INNER WEST COUNCIL

LOCAL TRAFFIC COMMITTEE MEETING

Item No: LTC0419 Item 9
Subject: Charles Street, Leichhardt - Proposed Angled Parking (Gulgadya Ward/Balmain Electorate/Leichhardt PAC)
Prepared By: David Yu - Engineer - Traffic and Parking Services
Authorised By: John Stephens - Traffic and Transport Services Manager

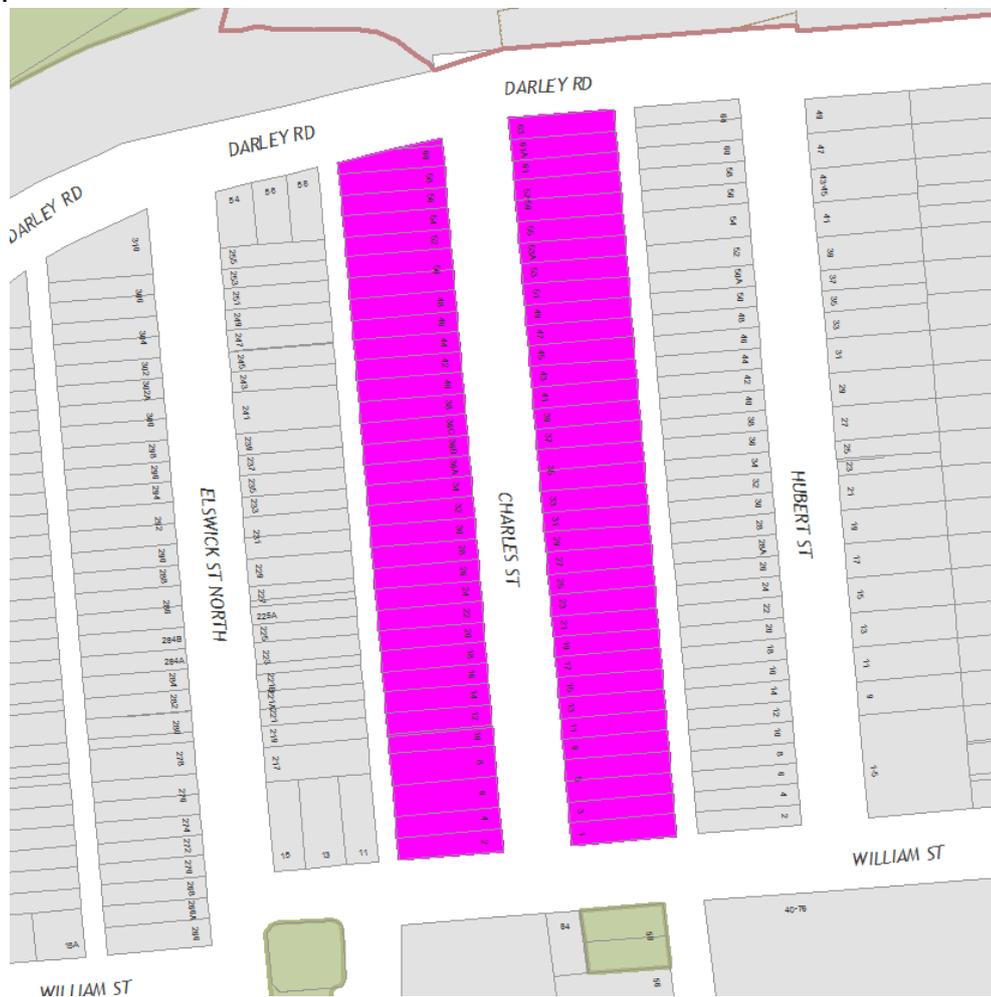
It is proposed to signpost '45° angle parking rear to kerb vehicles under 6m only' on the eastern side (odd numbered houses) of Charles Street as shown on the following map. This angle parking proposal is expected to increase the number of parking spaces in the street by approximately 15 spaces.

It should be noted that the road is not wide enough (13.3 metre carriageway) to allow angle parking on both sides of the road. The western side of Charles street will not be signposted with the exception of the 'No Stopping Zone'.

This proposed angle parking provides a typical cross-section of:

- 2.3m Parallel Parking Lane
- 6.2m Travel Lane
- 4.8m Angle Parking Lane
